# RESPONSE TO THE REVIEW #2 OF MANUSCRIPT NUMBER: NHESS-2022-93

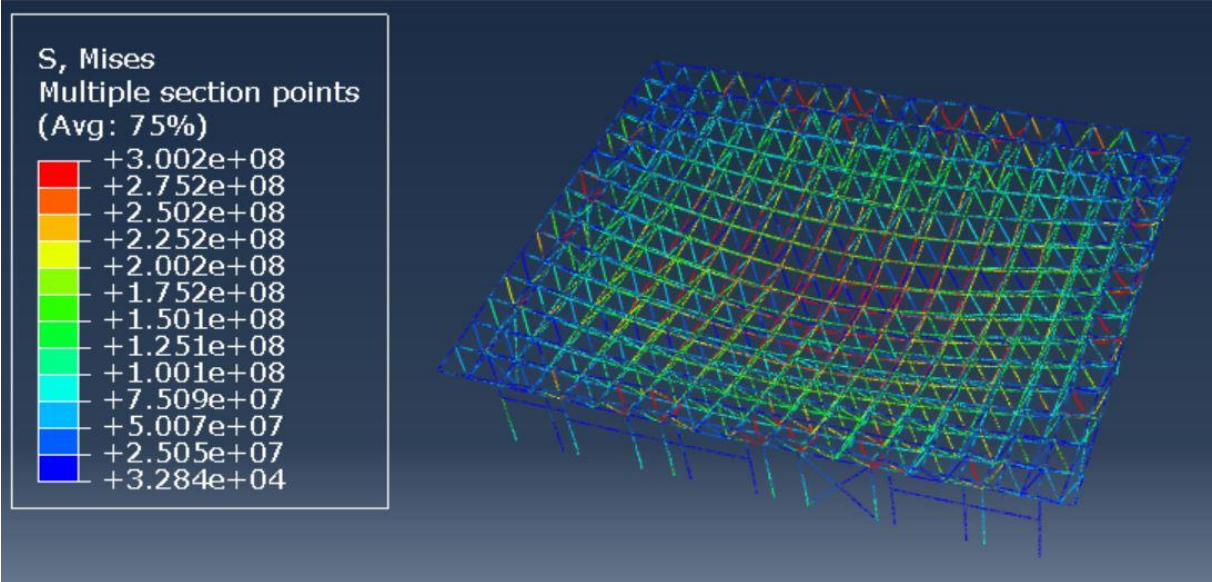
RC2#5 Many details of the structural analysis are missing; some assumptions need thorough revision:

The authors try to make a retrospective analysis of “what likely happened before the collapse”. While correctly considering best estimates of the roof snow load, they fail to consider best estimates for material properties – according to the new Eurocode for design of steel structures, prEN 1993-1-1:2022, S235 has mean of  $f_y = 1,25 \times 235 = 294$  MPa, mean of  $f_u = 1,2 \times 360 = 432$  MPa,  $\epsilon_u \geq 15\%$ . In

prEN 1993, 235 MPa is said to correspond to a 1% fractile of the distribution of  $f_y$ , thus a very low – very conservative – very unlikely value. Consideration of more realistic values for material properties would likely amplify the importance of failure modes related to loss of stability.

We took pessimistic values for material properties to somewhat offset the fact that we supposed a perfect initial state of the building (see our response to comment RC2#2). We thank the reviewer for those information about material properties and ran new simulations with  $f_y = 294$  MPa,  $f_u = 432$  MPa and  $\epsilon_u = 20\%$ . The results of the new simulations based on the assumptions proposed by the reviewer will be presented in the revised manuscript.

Moreover, it should be noted that following a remark by reviewer 1 on buckling, calculations have since been made showing clearly a problem at the level of the eastern façade for which we had little information on the distribution of the posts and their profile, as indicated on the paper. We conducted a new archival research, which has allowed us to clarify this point and the new simulations also took into account this aspect considering new (more realistic) features for the eastern facade.

Preliminary modelling results of loads leading to the different damage criteria, incorporating the two changes presented above, are presented below (table and figure).

Failure criterion	Loads (N.m-2)	
	Before	After
$y_{max} = 0.225$	1275	1360
$y_{max} = 0.27$	1500	1660
Elastic limit	1000	1320
Ultimate limit	2375	Not met
